**CITY OF LONGVIEW  
PURCHASING DIVISION**

Addendum No 1

**City of Longview Bid # 1819-57 Grounds Maintenance-Longview Arboretum**

**C2**

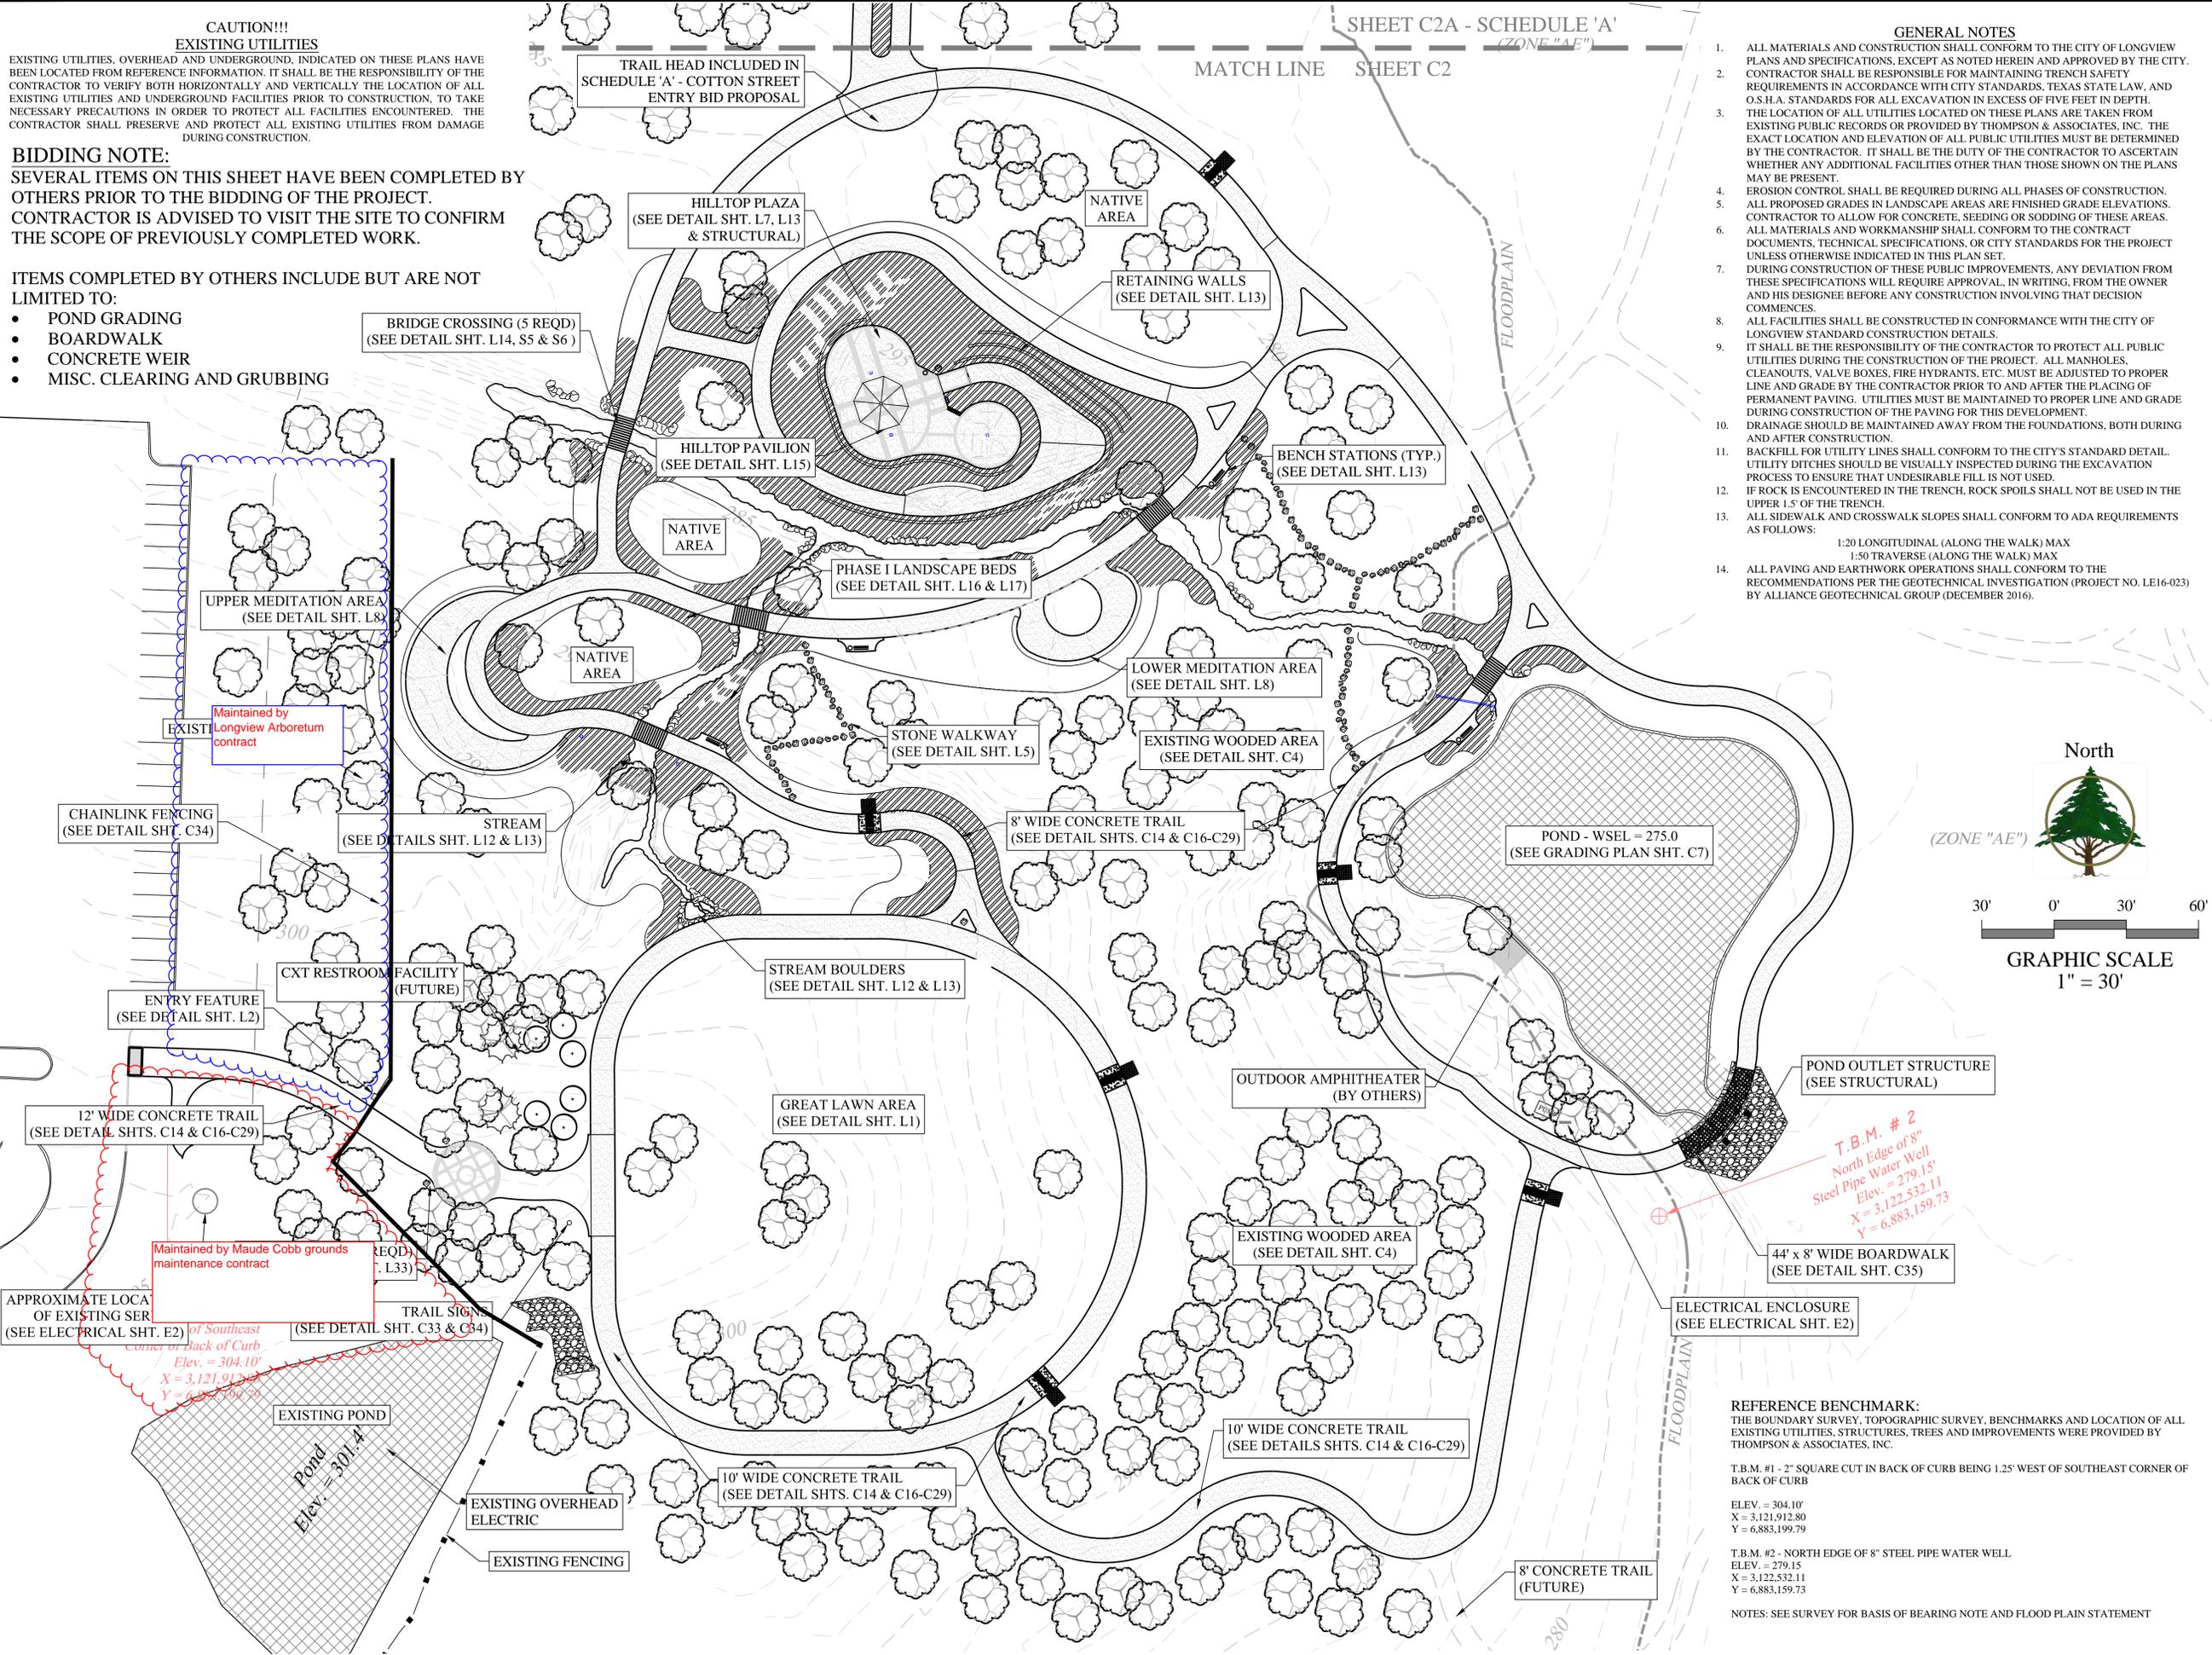
Mowing area for section that is adjacent to Maude Cobb parking lot:

Anything south of the of the concrete entrance path and east of the brick columns is part of the Maude Cobb grounds maintenance contract and shall not be maintained by Longview Arboretum contract.

Anything north of the concrete entrance pathway and west of the brick columns shall be maintained as part of the Longview Arboretum grounds maintenance contract.

Please see attached map.

Maintained by Maude Cobb grounds maintenance contract  
APPROXIMATE LOCATION OF EXISTING SERVICE LINE  
of Southeast Corner of Back of Curb  
Elev. = 304.10'  
X = 3,121,912.80  
Y = 6,883,199.79

Maintained by Longview Arboretum contract
